Re: Sanitary Survey Inspection of Meadow Hills Water and Sewer District PWS
(PWSID: MT0002925).

Meadow Hills Water and Sewer District (MT0002925)

May 15, 2025

**Pump House &
Water System
Configuration**
(5/15/25)

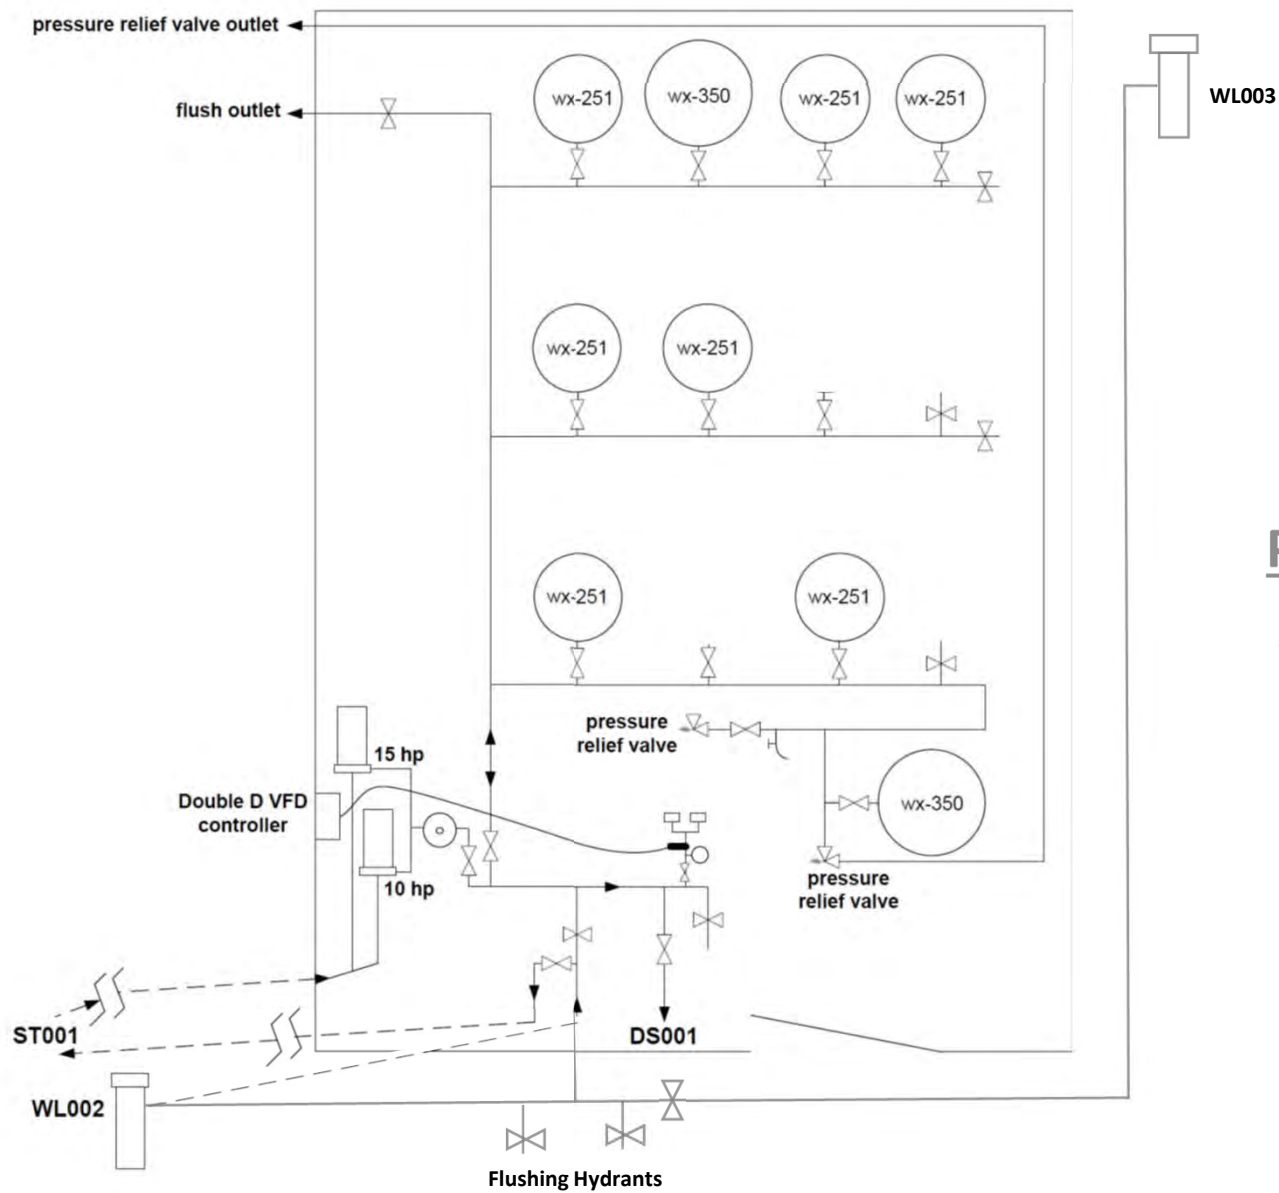
Top Right: Nine Captive air tanks float on the distribution header to provide back-pressure between pump cycles. It is recommended flushing the tanks on a regular basis to avoid water stagnation in the far tanks.
